Ecto Goggles Shield Kit #502-7024-00

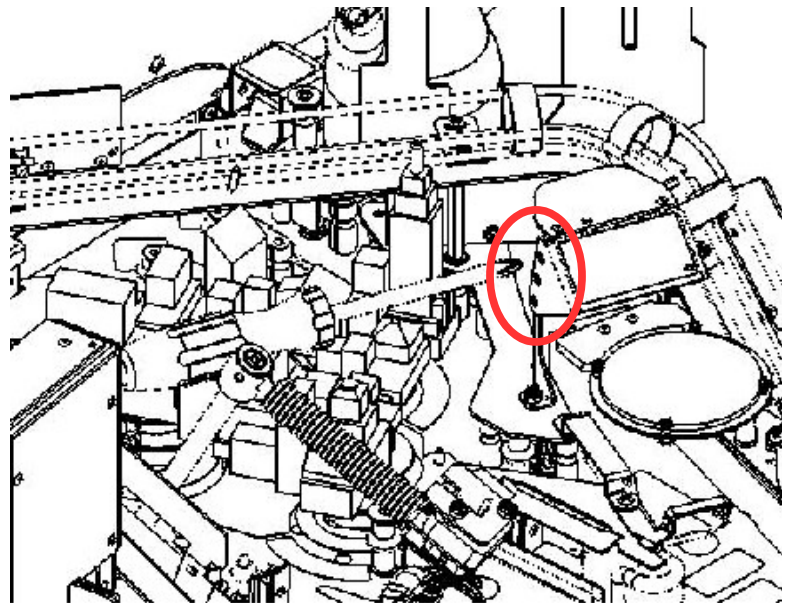
Explanation: It has been brought to our attention that some games are experiencing air balls which can hit and damage the Ecto Goggles LCD.

Solution: If your game was manufactured prior to serial number #263224, contact your distributor for the free of charge Ecto Goggles Shield Kit #502-7024-00.

2. Using a #2 Phillips head screwdriver, remove the three flat head screws from the side of the Ecto Goggle assembly.

3. Align the shield plate with the holes of the three screws that were just removed and screw in the plate using the same screws.
